Our Case Number: ABP-316272-23

Re: Bus Connects Templeogue/Rathfarnham to City Centre Core Bus Corridor Scheme
Templeogue/Rathfarnham to City Centre

**RE: TEMPLEOGUE/RATHFARNHAM TO CITY CENTRE
CORE BUS CORRIDOR SCHEME**

**SUBMISSIONS/OBSERVATIONS OF
DIARMAID MCGUINNESS,
2 AUBURN VILLAS, RATHGAR, DUBLIN 6, D06 EC91**

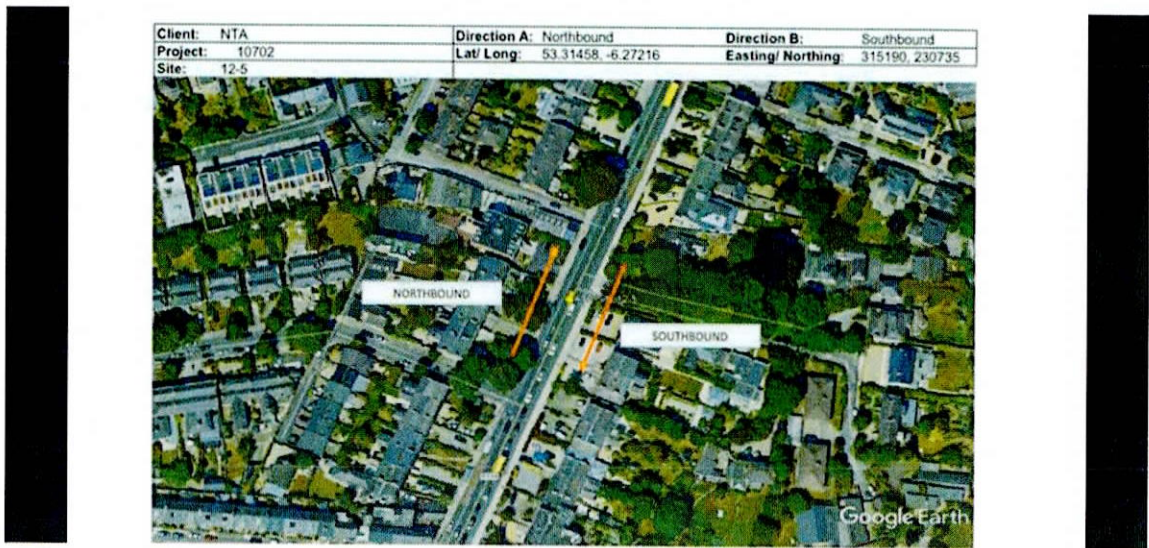
Table 5.3, at page 24, gives two readings for the ATC located there. The first is 12-5A, which is said to be the northbound direction and is indicated by a red arrow going down Rathgar Road towards the City. This gives AM movements of 358 and PM movements of 750 and at 12.5B, which is said to be the southbound direction, gives AM movements of 710 and PM movements of 393. It is important to understand what these figures are. They are not the traffic flows for any particular day, they represent an average flow for a day, said to be a weekday, representing the AM period between 7.00 and 8.00 a.m. and PM period between 5.00 and 6.00 p.m.

They have, however, been transposed in that they are wrong, because the figure attributed to the inbound flow is in fact the outbound southbound flow, and vice versa. The larger figure of the PM flow at 750 is in fact the traffic going in in the morning and the figure at AM 358 is the traffic going out in the morning. The same goes for the southbound flow recorded in that table for the

traffic recorded there as going out southbound at 710 is in fact the figure coming out in the evening at PM and the figure recorded as coming out in the evening at PM as 393 should be that recorded as going out in the morning in a southbound direction.
